BELLAIRE PROPERTIES INC. (CARSON’S CREEK)
PURCHASER EXTRAS

LOT 068 P.E #006 – Model - NIPISSING - 3210 - PHASE 5

NIPISSING
MODEL 3210
LOT 68

PROJECT
PROPOSED
TWO STOREY DWELLING
FOR: LORMEL HOMES
AT: INNISFIL

P.E.#: 006

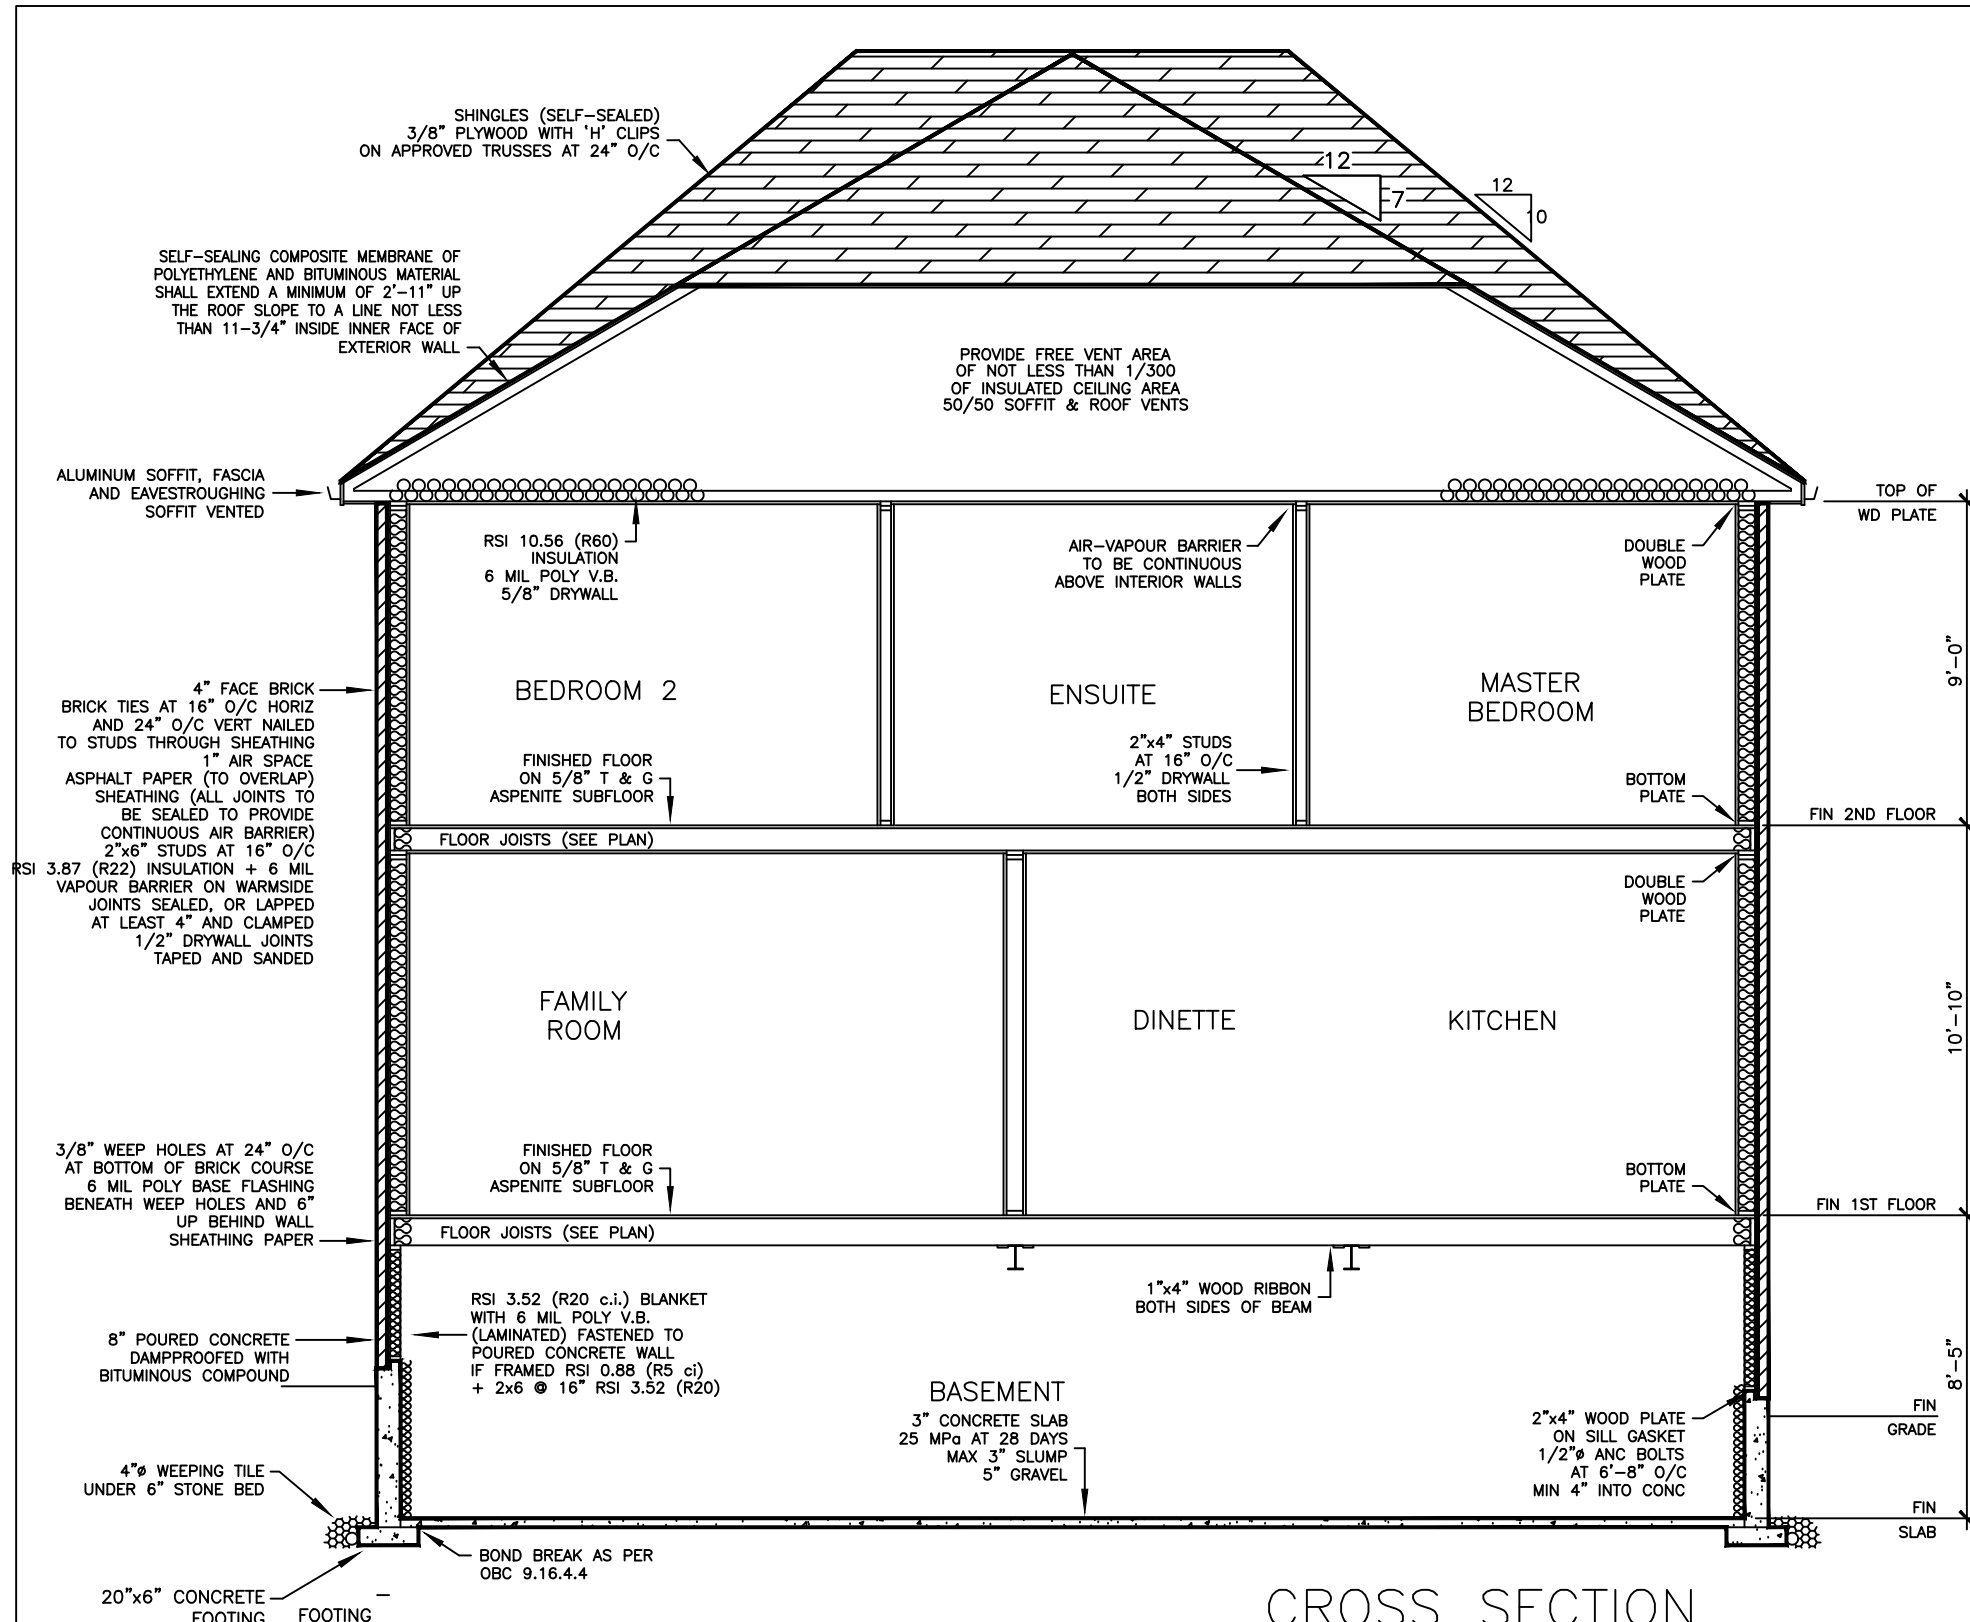
TRADE:	ITEMS TO BE COMPLETED	
Allstar Carpentry	#1	See Lot Specific
Tamarack Lumber	##1	See Lot Specific1
Mansteel	##1	See Lot Specific1
Kingswood	##1	See Lot Specific1
Internazionale Electric	##1	see lot specific1
